Re: Waterloo Wind farm stage 2 Application to Vary Generation License and add 6 turbines (V117)

Relationship to the Waterloo Wind farm stage 2 Project: near neighbour

Figure 5-1 Planning

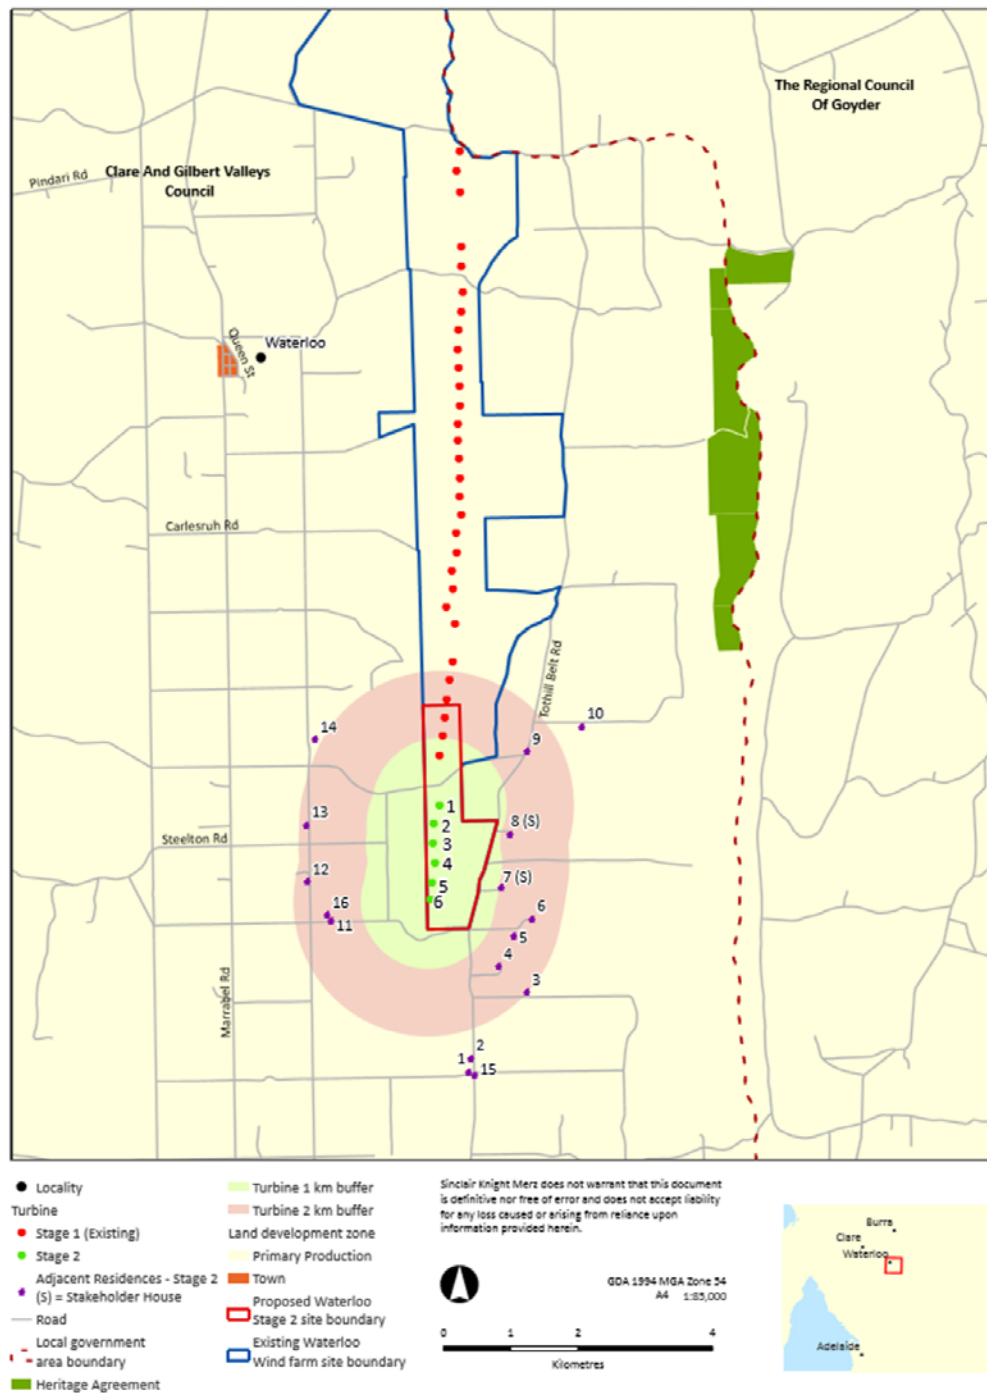
This shows a very narrow view and misrepresents the environment surrounding the turbines. It is not evident from the map provided in the Application that there are 12 houses within 2 km of the proposed stage 2 turbines.

See map below from 2012 Development Application Figure 5-1 Planning. This gives a more representative view of the wind farm site and surrounds and shows how unacceptably close the turbines are sited to local houses.

10. The setbacks to houses for the Waterloo stage 2 development are insufficient, inconsistent with and significantly less than the 2 km setbacks for the neighbouring Stony Gap wind farm (proposed by the same developer and operator of the Waterloo wind farm stage 1 – Energy Australia.) Residents at Waterloo should be allowed the same 2 km setbacks as Stony Gap residents.
11. Turbines are sited too close to neighbours’ boundaries. Turbine blades will over-sail neighbours land. This is an unacceptable hazard according to SAFEWORK SA submission to the 2011 Ministerial Wind farms DPA because of the risk of turbine failure. Neighbours should not have to be subjected to whirring blades immediately overhead whilst utilising their property.
